**A. ADMINISTRATIVE REPORT & DECISION**

**Project Name:** Firestone at 108<sup>th</sup> SE

**File Number:** LUA16-000782,ECF,CU-A, SA-A, MOD

**Project Summary:** The applicant is requesting Administrative Site Plan Review, Administrative Conditional Use Permit, Environmental Review, and four (4) modifications to redevelop an existing CA zoned site with a proposed 8,261 square foot single-story building that will accommodate a new vehicle service and repair business. Associated improvements with the redevelopment include surface parking for 24 vehicles, stormwater detention and water quality treatment, and landscaping. Access to the site will remain in approximately the same location as the former restaurant along the 108<sup>th</sup> Ave SE frontage. The applicant also requests four (4) modifications to code requirements related to frontage improvements along 108<sup>th</sup> Ave SE and 109 Ave SE, garbage and recycling enclosure requirements, and loading space standards. The existing restaurant on the subject property will be removed. The site contains no critical areas.

EXHIBIT 3

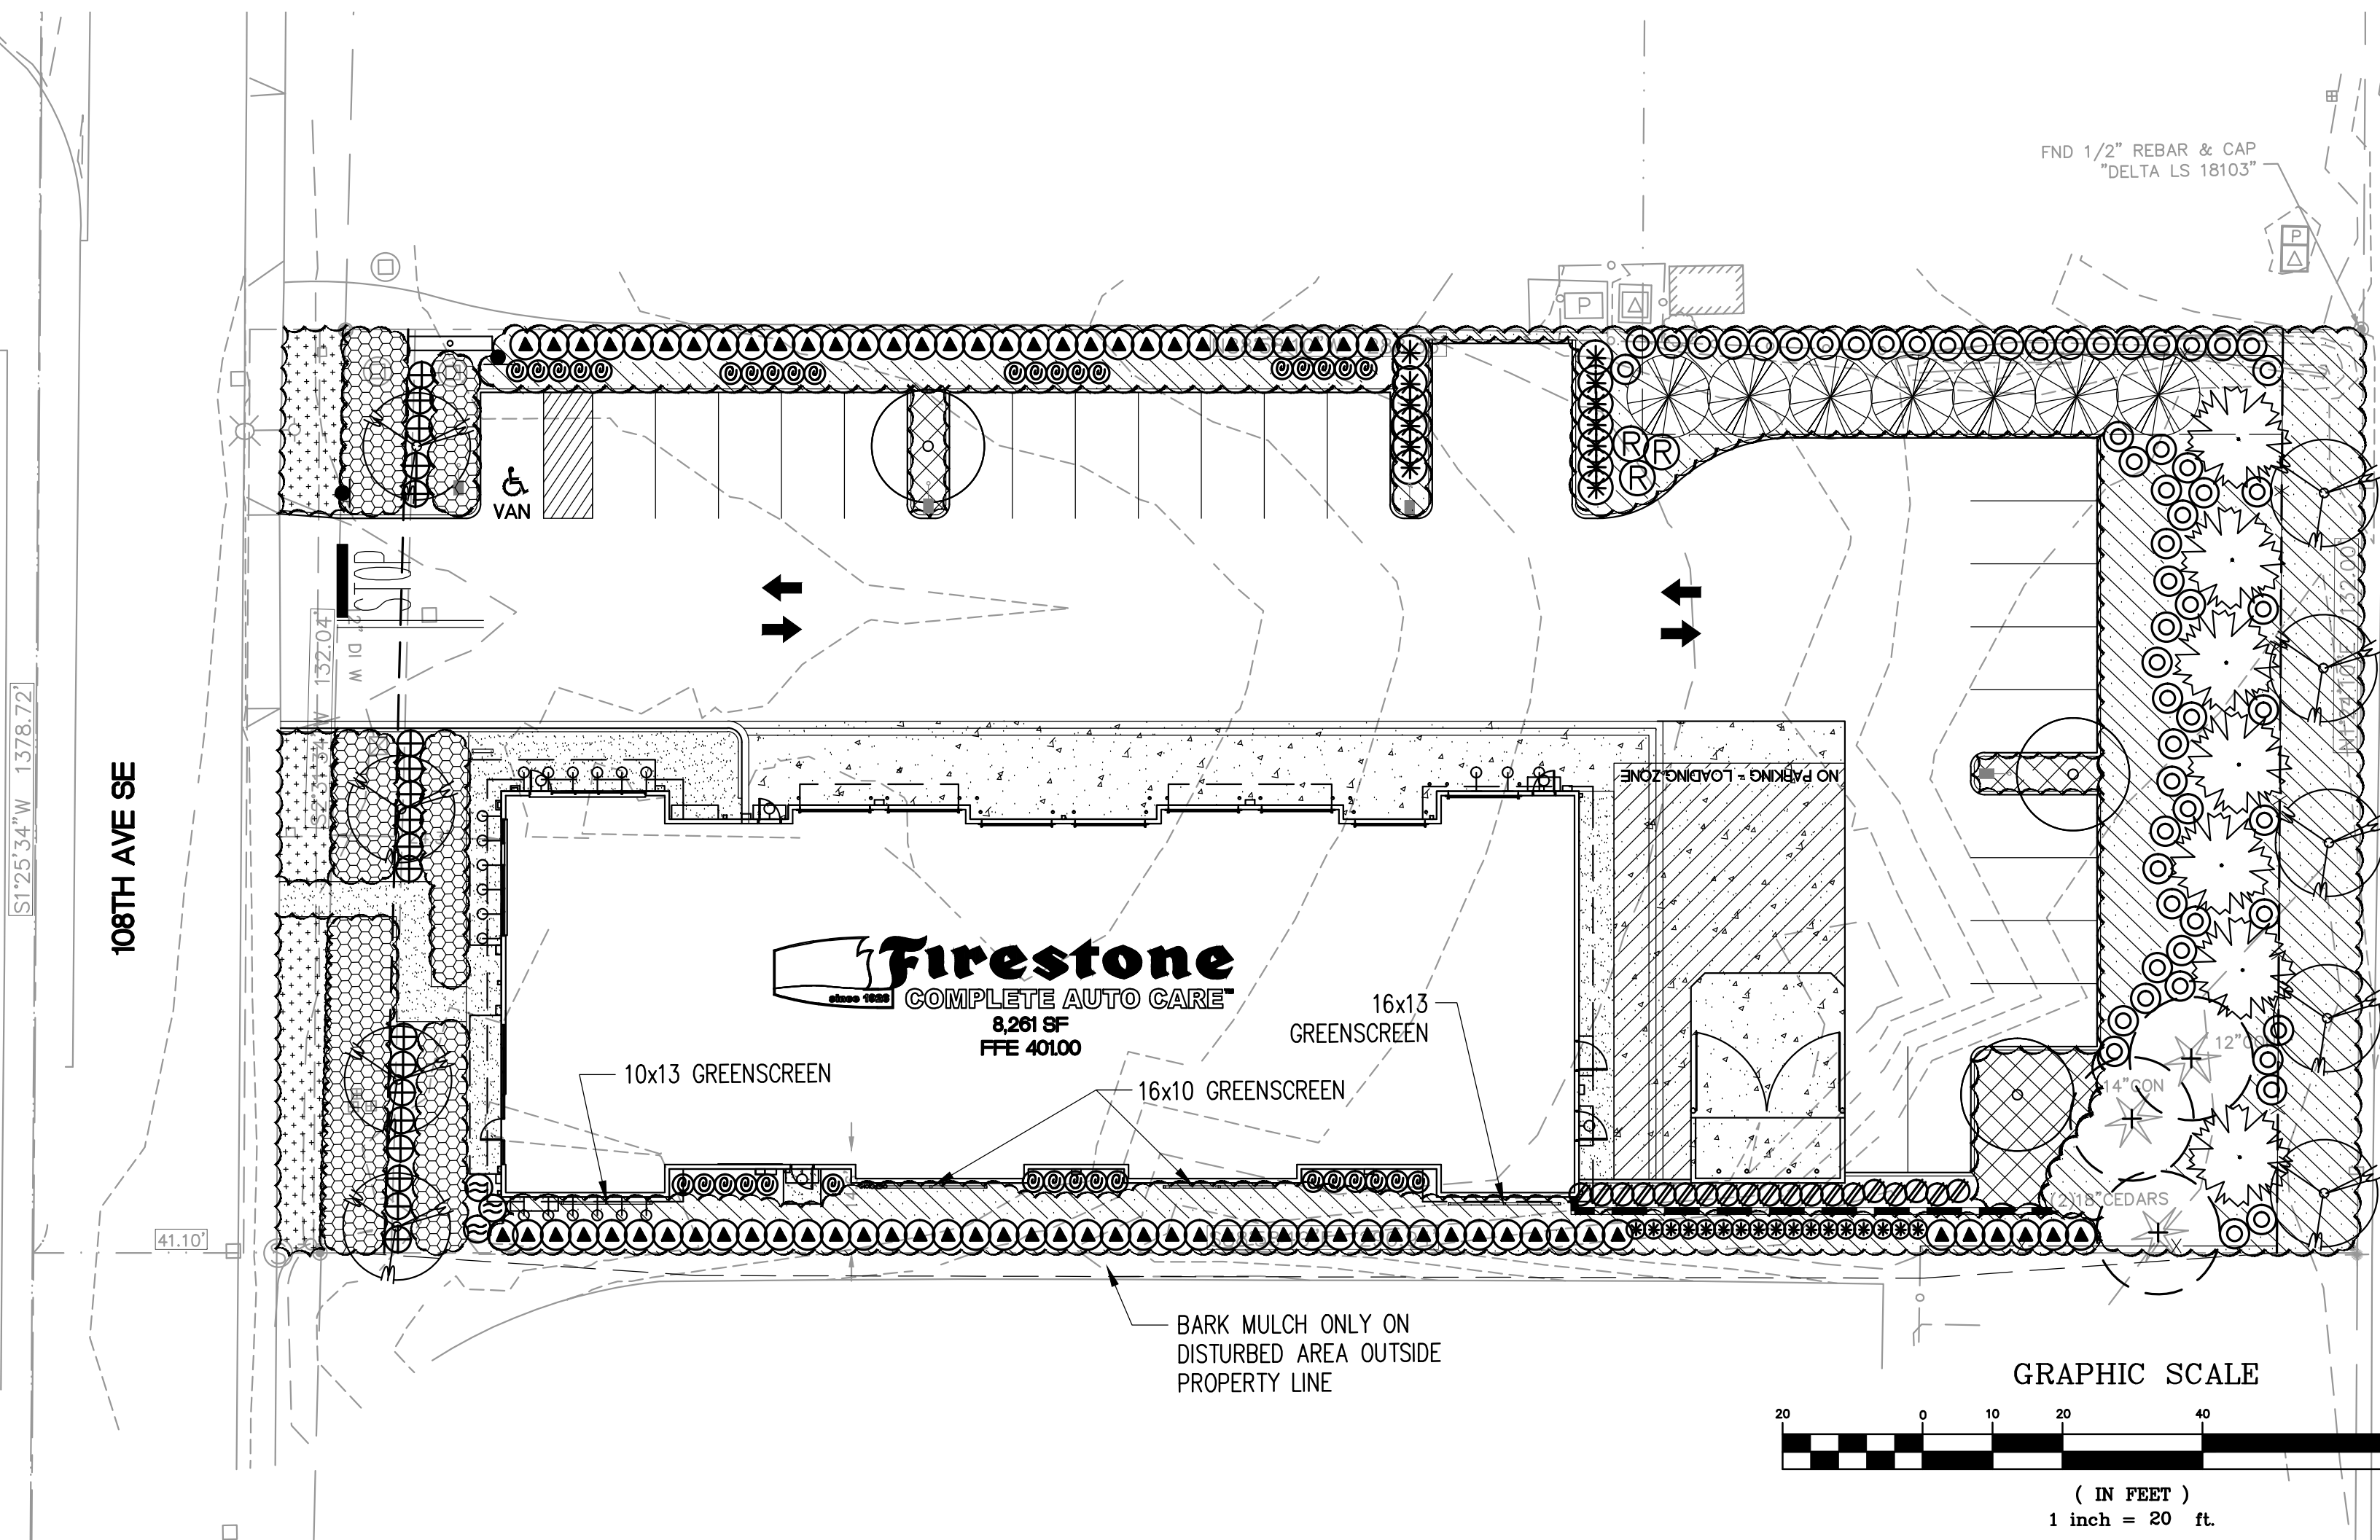
Ten (10) feet of street frontage landscaping is required to be planted on the subject property along 108<sup>th</sup> Ave SE. The proposed landscape plan shows three (3) Parkway Maple trees, Dense Spreading Yew, and Blue Oat Grass provided in a 10 to 11 foot wide planting area south of the subject property's driveway. A pedestrian pathway bisects the street frontage landscaping, shifts 90-degrees and runs parallel with the building and then shifts 90-degrees again and leads to the entrance. The number of shifts along the frontage is unnecessary and will likely lead to pedestrians walking on the landscaped area as it presents the shortest distance between the sidewalk and the entrance. Therefore staff recommends as a condition of approval, the applicant submit revised landscape plan that provides a direct perpendicular connection from the street frontage building entrance to the sidewalk. The revised landscape plan shall be submitted with the building permit application to be reviewed and approved by the Current Planning Project Manager prior to building permit approval.

North of the subject property's driveway, a ten (10) foot wide perimeter parking lot landscaping screen is shown with one (1) Parkway Maple tree, five (5) Dense Spreading Yew, and Blue Oat Grass within a 240 square foot planting area. The amount of shrubs shown does not meet the minimum planting rate of one (1) per 20 square feet of landscaped area. Therefore staff recommends as a condition of approval, the applicant submit a revised landscape plan that provides a minimum of seven (7) additional shrubs within the perimeter parking lot landscaping screen. The revised landscape plan shall be submitted with the building permit application to be reviewed and approved by the Current Planning Project Manager prior to building permit approval.

Interior parking lot landscaping is provided via bulb extensions that are at least five (5) feet in width extending from perimeter landscaping. The bulbs provide approximately 771 square feet of interior lot landscaping which exceeds the 15 square feet per parking space requirement; however three (3) of the five (5) interior bulbs do not contain any shrubs as required. Therefore, staff recommends as a condition of approval the applicant submit a revised landscape plan that provides the shrubs within the interior parking lot landscaping bulbs at the required rate of one per 20 square feet of landscaped area. The revised landscape plan shall be submitted with the building permit application to be reviewed and approved by the Current Planning Project Manager prior to building permit approval.

The site abuts a residential zoned lot along on the northwest portion of the site. The landscape plan provides a 15-foot wide planting area with seven (7) Incense Cedar trees planted 11-feet on center with Dwarf Winged Euonymus, PJM Rhododendron, Arborvitae, and Salal planted at the base of the trees. The planting should provide the required minimum of 50-percent sight-obscuring screen intended for the visual barrier.

17 TRASH ENCLOSURE ELEV. SCALE: 1/4"=1'-0"

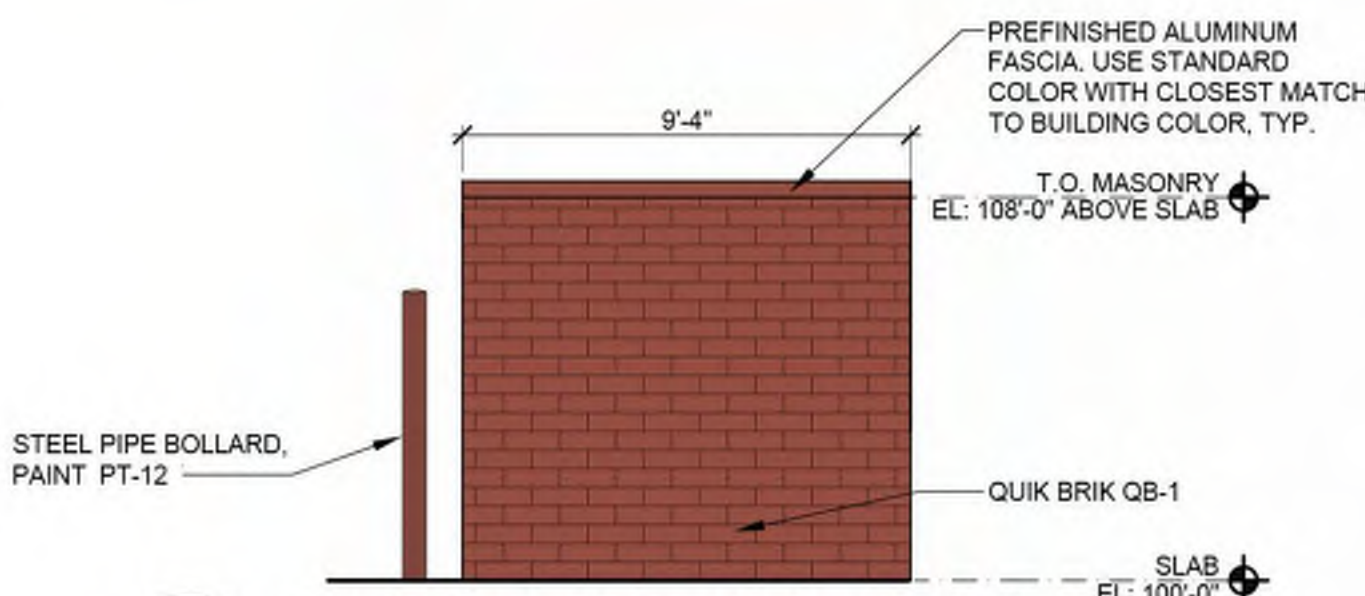
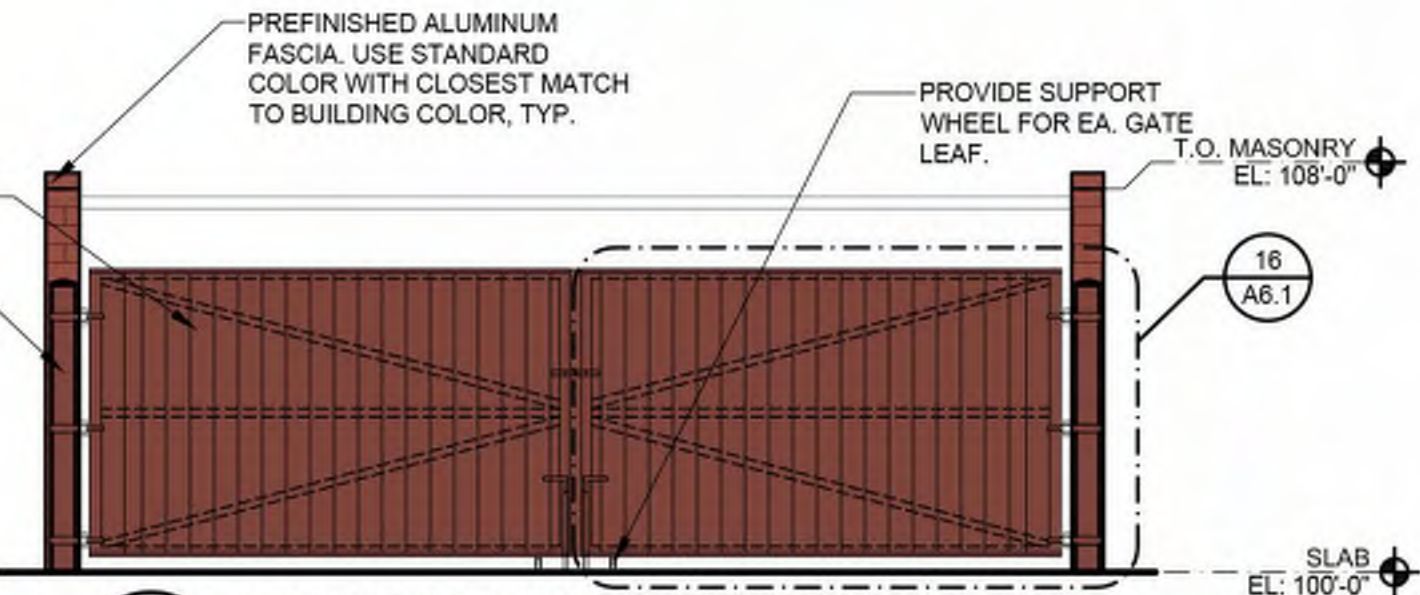
met	<i><b>Staff Comment:</b> The garbage and enclosure area is screened on all sides via an eight-foot high brick enclosure with a cedar wood fence gate. A standing seam metal roof is also shown on the proposed elevations (Exhibit 17). Self-closing doors are not identified on the plan. Therefore, staff recommends as a condition of approval, the applicant submit a revised elevation plan that provides a detail cut sheet identifying the self-closing mechanism for the enclosure doors. The revised elevation plan shall be submitted with the building permit application to be reviewed and approved by the Current Planning Project Manager prior to building permit approval.</i>
✓	<p><b>Standard:</b> Service enclosures shall be made of masonry, ornamental metal or wood, or some combination of the three (3).</p> <p><i><b>Staff Comment:</b> The enclosure is made of brick with aluminum fascia. Enclosure doors are comprised of 1x6 cedar fence pickets.</i></p>
